NORTH FALLS

Offshore Wind Farm

Draft Marine Mammal Mitigation Protocol (Clean)

Document Reference: 7.7
Volume: 7
Date: March 2025
Revision: 1

Appendix B. Plots for Comparable Hammer Strike Energies

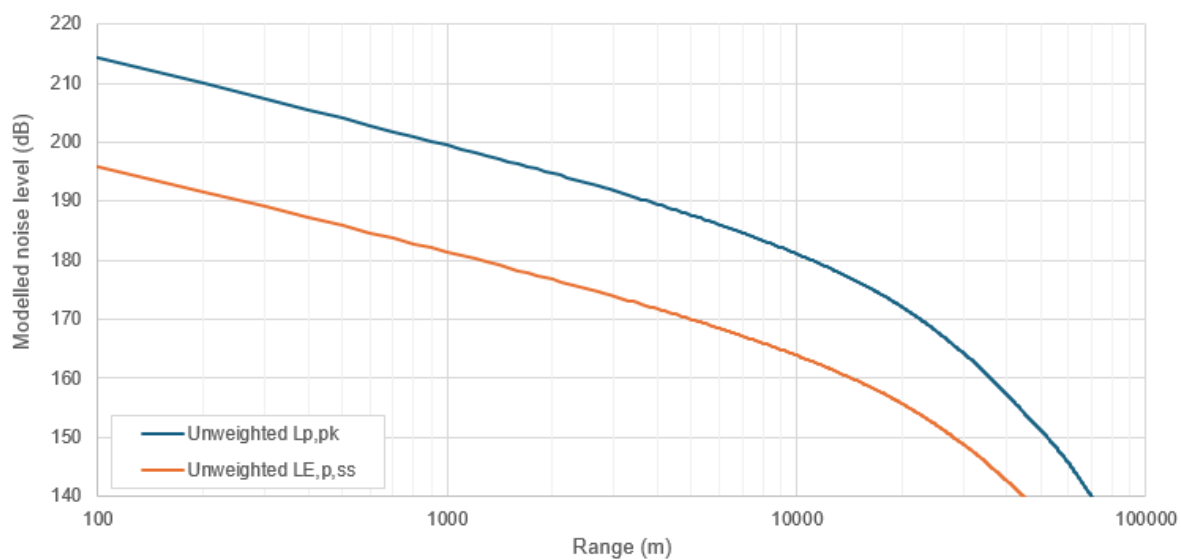
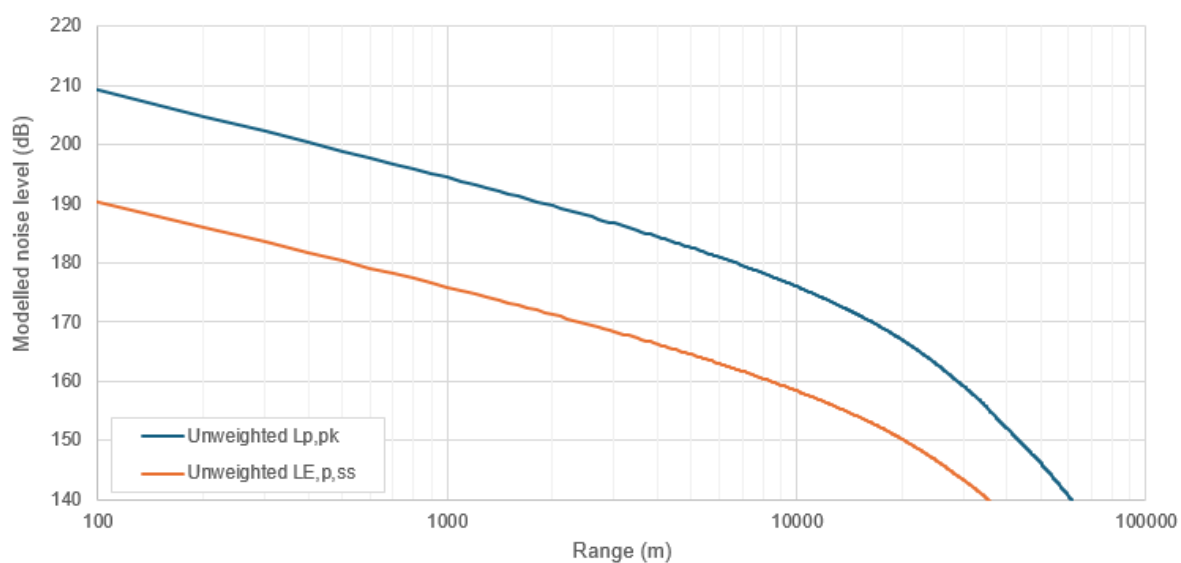
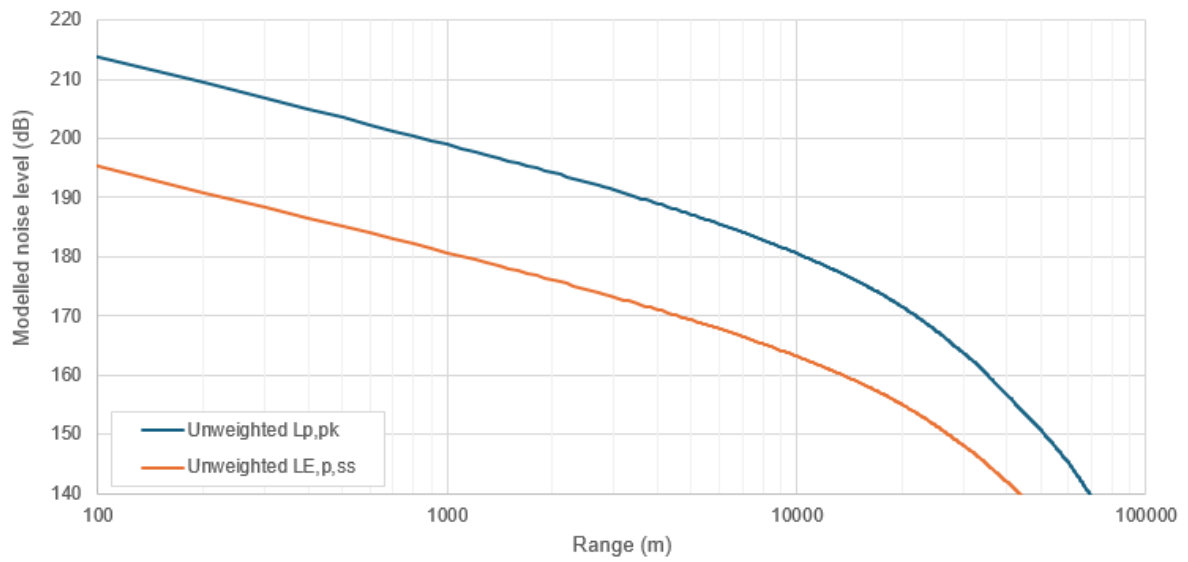
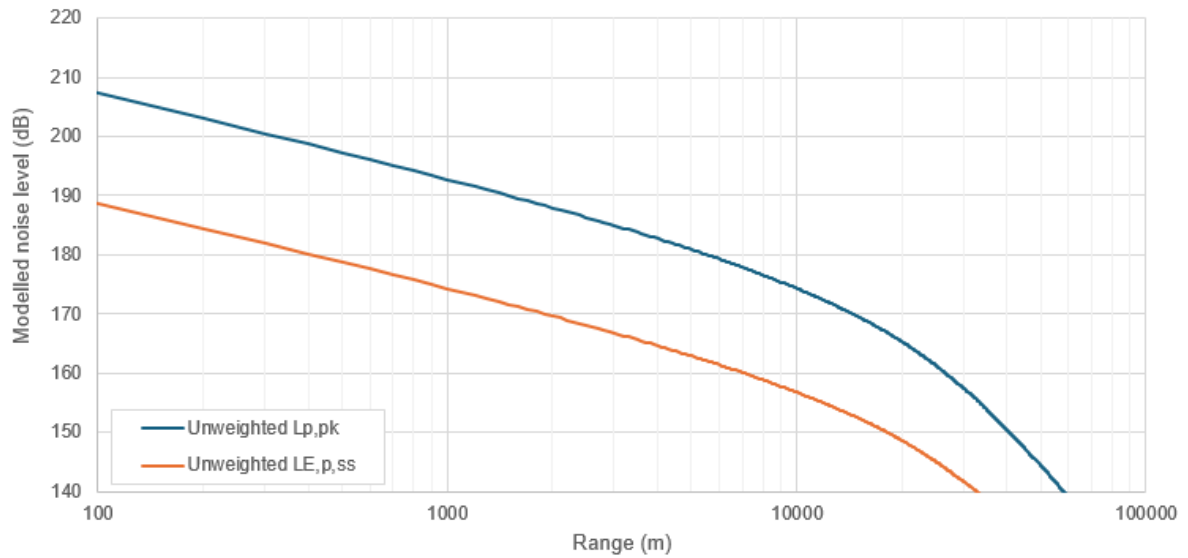
Consultee	Reference	Comment	Response / where addressed in the MMMP
		the final MMMP. The MMO suggests that the Applicant consults with the specific UXO contractor to determine the appropriate parameters for safely deploying bubble curtains. If environmental conditions are not conducive to the use of a bubble curtain, then the MMO recommends postponing any high-order detonations until conditions are suitable.	
MMO	MMO-195	The purpose of the noise monitoring during construction is to determine the actual underwater noise levels on site for comparison with the modelled levels presented in the ES. The MMO acknowledges that the measurements taken during installation will be constrained by various factors such as the piling plan and site limitations and a direct (like-for-like) comparison with a modelled scenario is unlikely to be possible. Nevertheless, even if the piling locations and choice of transects would not be matched precisely, both modelling and monitoring should provide enough information to deduce some envelope of received level curves in each case. Thus, some sort of comparison/s in the form of 'level vs range' plots (for comparable hammer strike energies), with the associated envelopes of variability, should be possible and would be expected. Therefore, the MMO recommends that such a plot is provided.	The Applicant has noted this comment from the MMO, therefore, these plots have been provided in Appendix B as part of this revised Draft MMMP (Revision 1).
